PUBLIC HEARING MEMORANDUM

SUBJECT: **Petition #240-23** Request to allow ground floor residential use, to exceed by right height and stories, and a parking waiver at 290 Watertown Street, Ward 1, Newton, on land known as Section 11 Block 14 Lot 03, containing approximately 11,473 sq. ft. of land in a district zoned BUSINESS 1. Ref: 7.3.3, 4.4.1, 4.1.2.B.3, 4.1.3, 5.1.4, 5.1.13 of Chapter 30 of the City of Newton Rev Zoning Ord, 2017.

290 Watertown Street

Proposed Site Plan

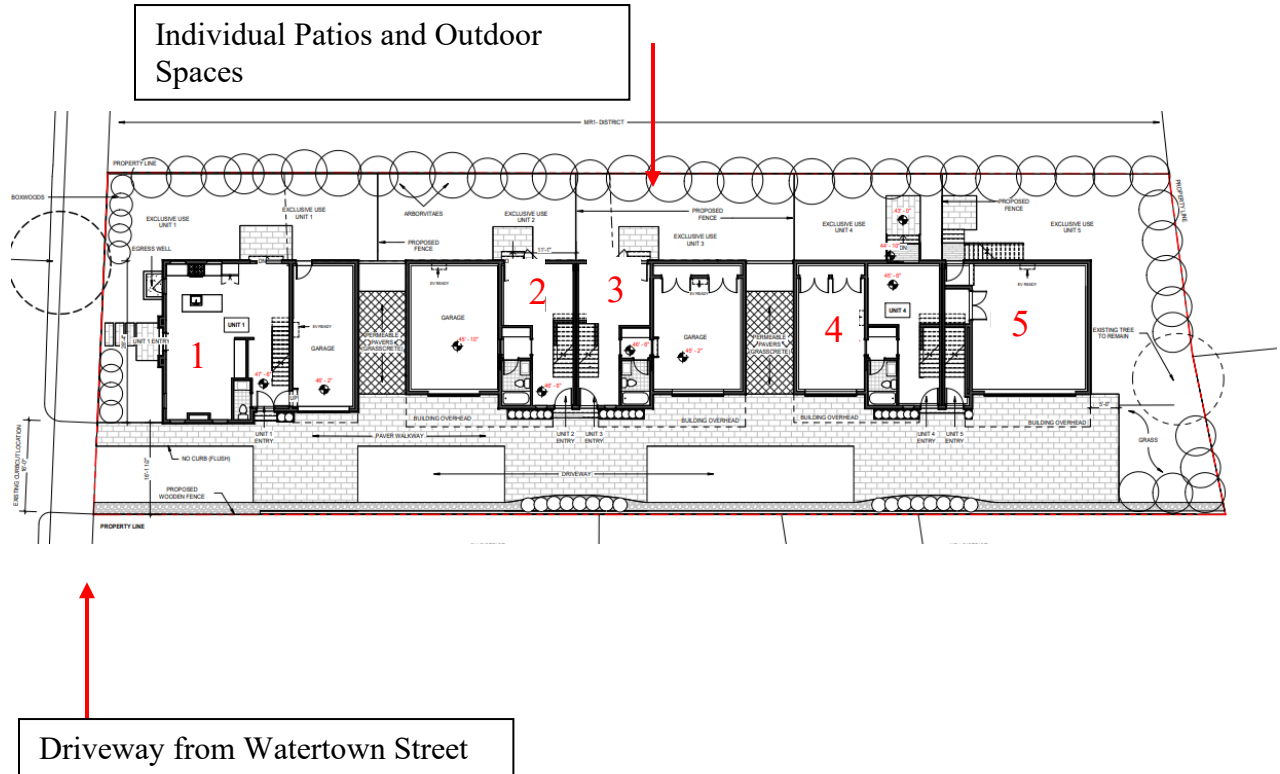
The 3-bedroom units range in size from 2,093 square feet to 2,436 square feet. The rear unit, Unit 5, includes the only two-car garage and a second-floor deck and stairs leading to the outdoor space. Unit 1 is 2,258 square feet, Unit 2 is 2,436 square feet, Unit 3 is 2,436, and Unit 4 is 2,114 square feet. The five units are spread across three separate buildings structures with the front building on Watertown Street containing one unit and the middle and rear buildings containing two units each. The interior building (Units 2 and 3) is separated from the front and rear buildings by a parking stall (8.5 feet in width) composed of permeable pavers (grasscrete). The design of a smaller-scaled building in the front with three separate buildings overall helps to reduce the overall mass of the 5-unit development. The parking stall dimensions at 8.5 by 18 feet do not comply with the minimum stall width required by NZA of 9 feet by 19 feet. The petitioner notes that this parking stall width will be increased to be compliant.

Planning notes there is a paver walkway indicated on the civil plans and suggests that this is delineated visually to indicate the walking path for visitors and residents, perhaps by utilizing different paver materials.

One parking stall each is located on either side of the center building totaling two surface parking stalls composed of grasscrete pavers. These two parking stalls are not dimensionally compliant with the NZA but the petitioner notes that the parking stalls will be revised to be compliant by the time of building permit application. Planning recommends this is included as a condition prior to building permit should this application be recommended for approval by the LUC.

*290 WATERTOWN STREET
NEWTON
MASSACHUSETTS*

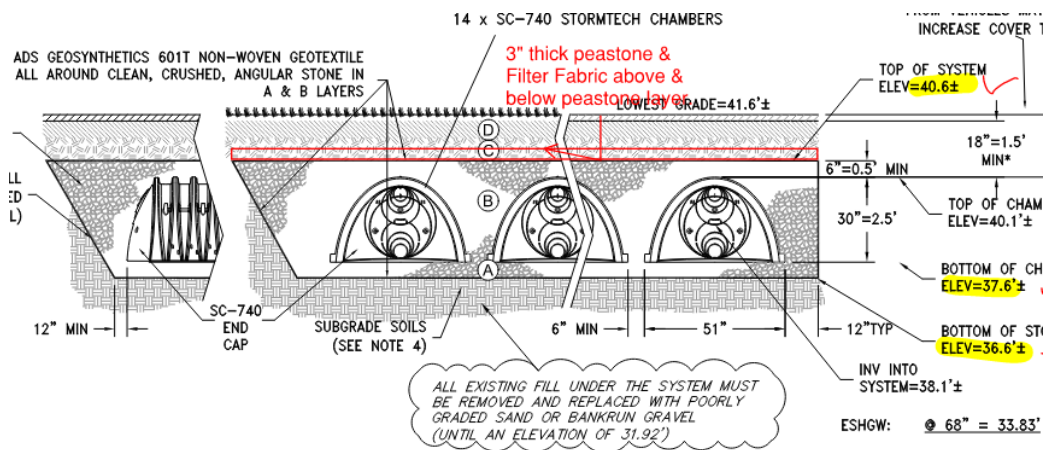
This proposed permit entails the demolition of an existing two-family unit and the construction of a 5-unit residential dwelling. The site has 60-feet of frontage along Watertown Street to the north, and residential dwellings to the south, east and western property lines. The site plan has a north arrow that is incorrectly rotated 180°. A high point elevation of 47-feet is near the front of the home and slopes gently to the northwest to a low point of 39-feet. The new dwelling will have on grade garages, a turning template plan should be submitted to demonstrate proper

maneuvering of various vehicle pulling into each garage and backing out to exit the site. I have a concern for snow removal and storage the applicant needs to explain where snow will be stored as the site does not have much open space along the driveway. On the average a 3-foot-high retaining wall within the setback is proposed along the east, south and western property lines the design needs to ensure that natural surface water flows are not impacted. The wall allows for the construction of flat side yards of patios and the access driveway.

The engineer of record has designed a stormwater collection system that meets the DEP & DPW Stormwater Regulations by collecting and infiltrating runoff from the driveway & roof within 14- infiltration units along the western & northern property lines. The proposed Operations & Maintenance (O&M) plan is acceptable for the design intent, however access to the units maybe problematic. A minor addition is need for the proposed infiltration system; the City requires a 3" thick layer of peastone with filter fabric above & below the peastone covering the entire system as shown below.

In accordance with the City Ordinance B-52 new concrete sidewalk, and granite curbing is required.
